DAC 08/12/20 – DA2020/00758 - 59 SCENIC DRIVE, MEREWETHER - DWELLING HOUSE ALTERATIONS AND ADDITIONS

ITEM-44 Attachment A: Item 42 - DAC 01/12/20 - DA2020/00758 - 59
Scenic Drive Merewether - Dwelling house -
Alterations and Additions

**DAC 01/12/20 - DA2020/00758 - 59 SCENIC DRIVE
MEREWETHER - DWELLING HOUSE - ALTERATIONS AND
ADDITIONS**

ITEM-42 Attachment A: Submitted Plans

Figure 1 - View looking south from Scenic Drive frontage over site

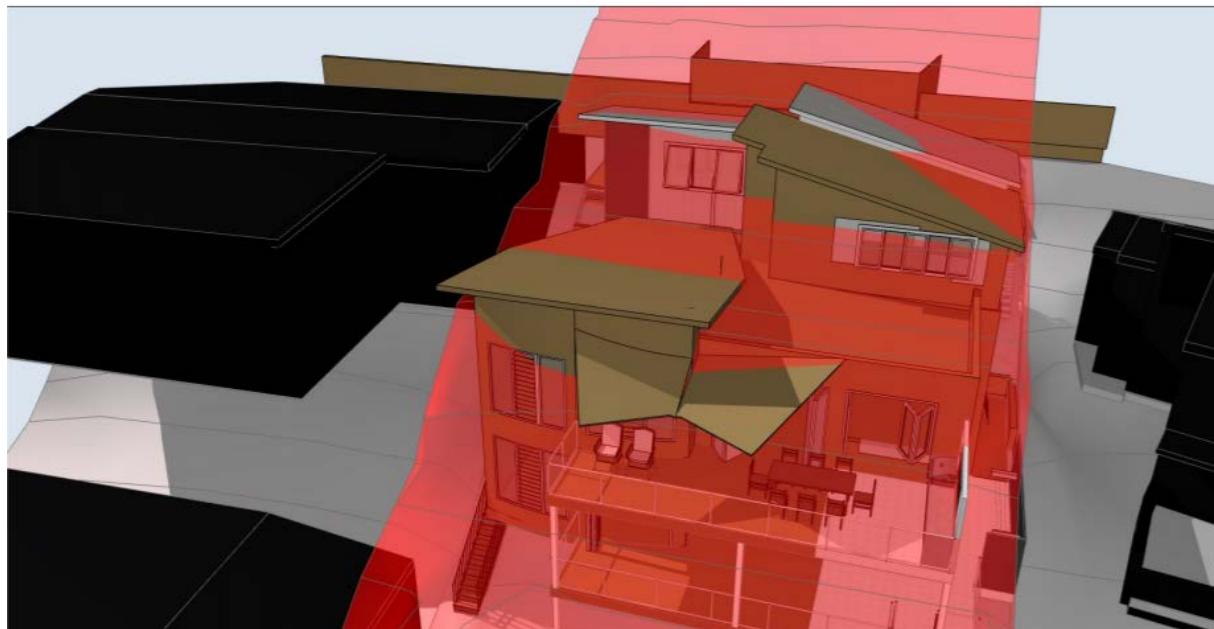
The proposed development will result in a maximum height of 9.717m, equating to an exceedance of 1.217m or 14.3% above the height of buildings development standard for the subject land. Existing and proposed building height exceedances are depicted below.

The three-dimensional views of the subject proposal are shown below, with the existing elements in dark beige, proposed elements in grey and the adjacent dwellings shown in black. The height of buildings envelope is modelled in red.

Figure 4 - Side setback departure towards western common boundary with area of departure highlighted in yellow.

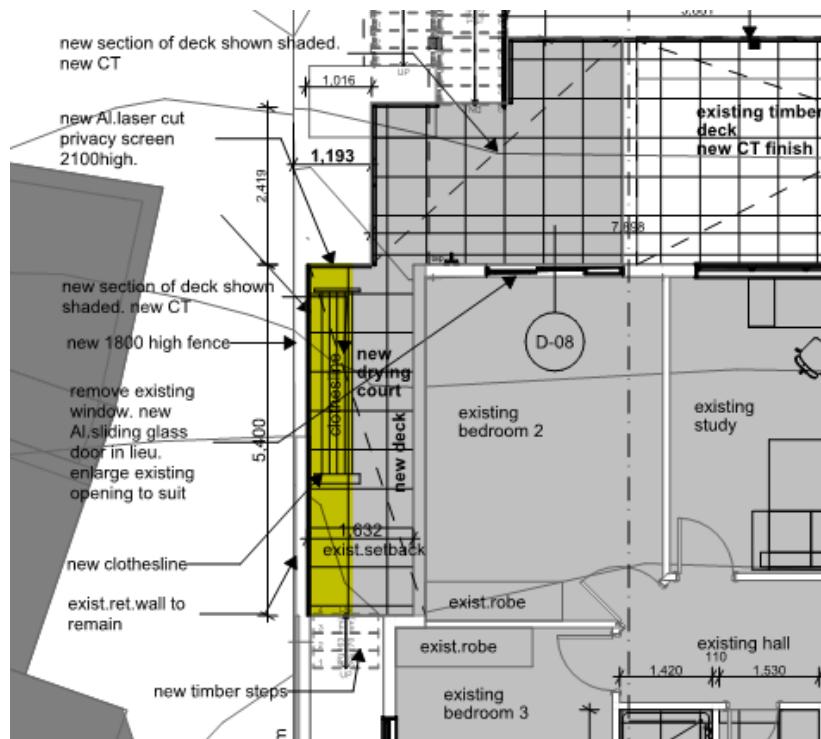
The majority of the proposed development is within the building envelope when measured from side and rear boundaries with the exception of part of the 'new drying court deck' which encroaches within the 900mm side setback as depicted below:

A small section of the eaves of the western side of the proposed addition over the existing garage also slightly projects outside the nominated building envelope controls.

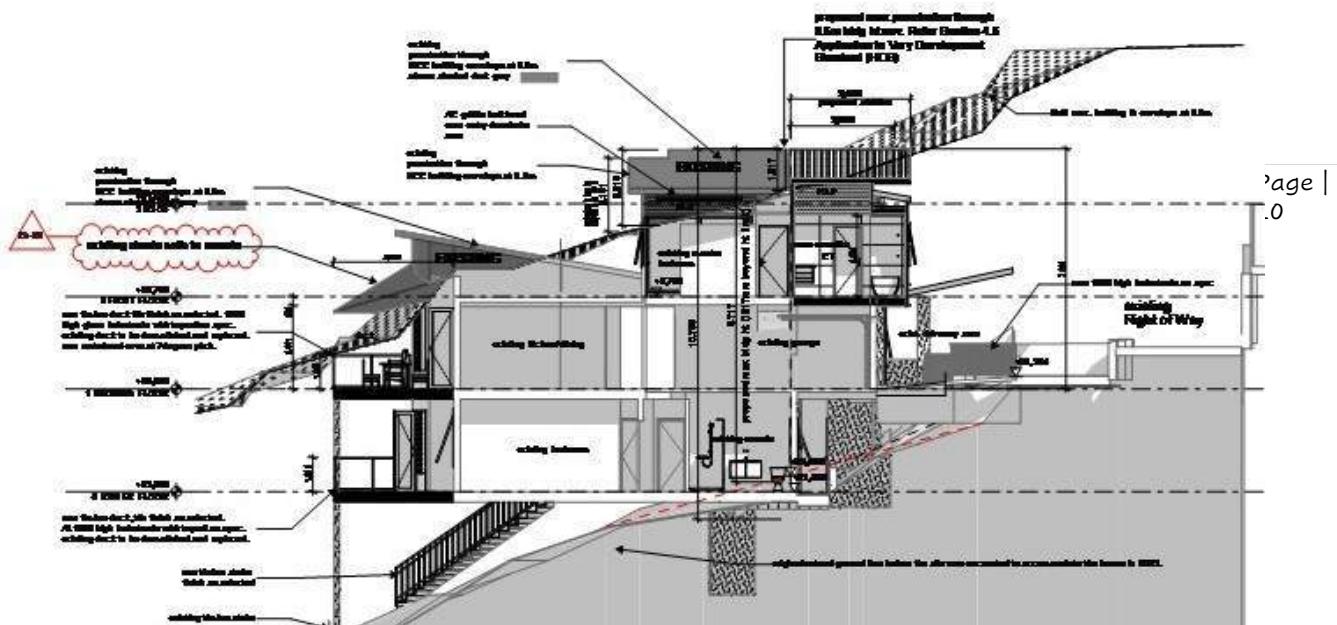
The further submission from the consultant acting for the owners of No.28 Hickson Street questions the figure quoted in the Section 4.6 Application to Vary Development Standard.

We confirm that the figure quoted, that is an exceedance of a maximum of 1.217m beyond the 8.5m height limit is correct. Refer sectional image Figure 10 on Page 9. As discussed in detail on pages 5- 10, the three dimensional nature of the slope of the building height envelope is such that it varies with the topography of the site. Thus it varies depending upon where the particular elevation or section drawing is taken. The most accurate depiction of the building height envelope in relation to the existing house and the proposed additions is the three dimensional building plane shown in the computer generated images Figures 1- 12.

Figure 16: South Elevation showing the compliance of the addition in relation to the CoN Building Envelope.

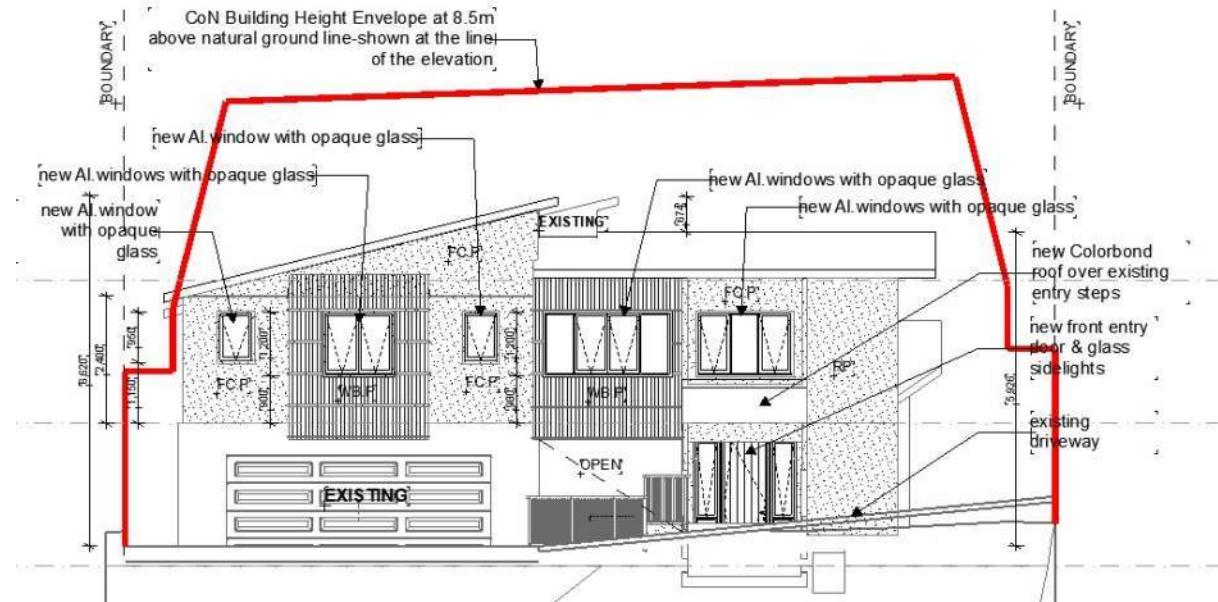
Only the eaves of the western roof project outside the envelope. The proposed lift and first floor hallway are contained fully within the prescribed Building Envelope.

Figure 20: South Elevation noting the proposal in regard to the CoN Building Envelope and the proposed height of the roof over the new Hallway/Lift.

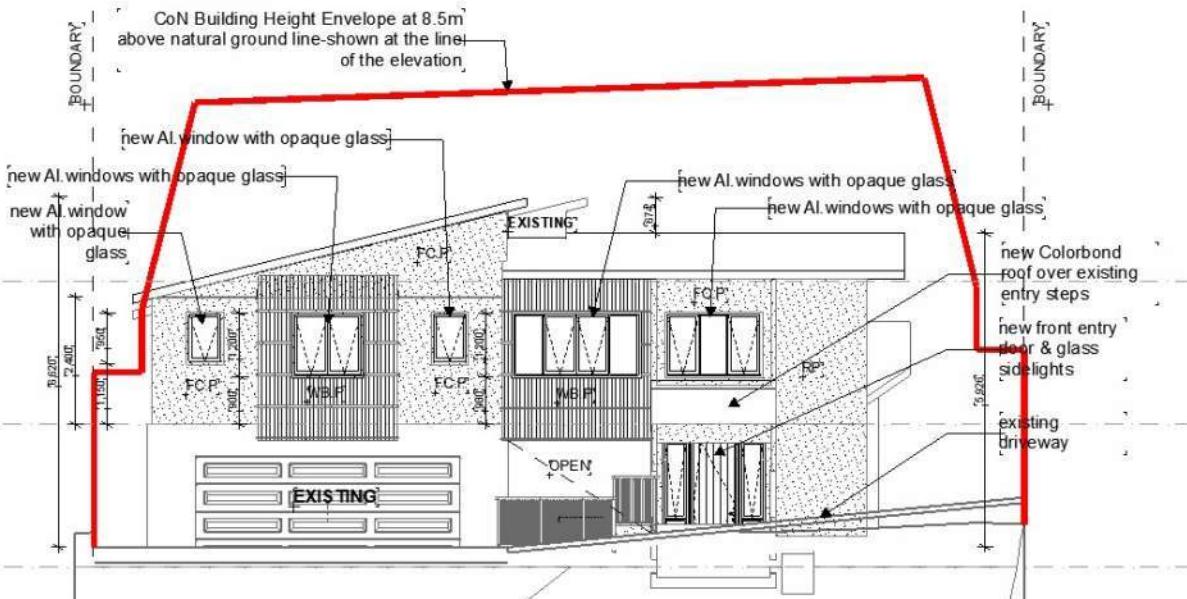
It is the roof over the new First Floor Hallway and the associated lift which impacts upon the city views from the rear gardens of No.26. Given that the proposed height of this roof is 674mm lower than the highest point of the existing roof, and that there are no other reasonable locations for the lift to connect to all floors, I am of the opinion that there is no opportunity for a more reasonable outcome. Refer Figure 20.
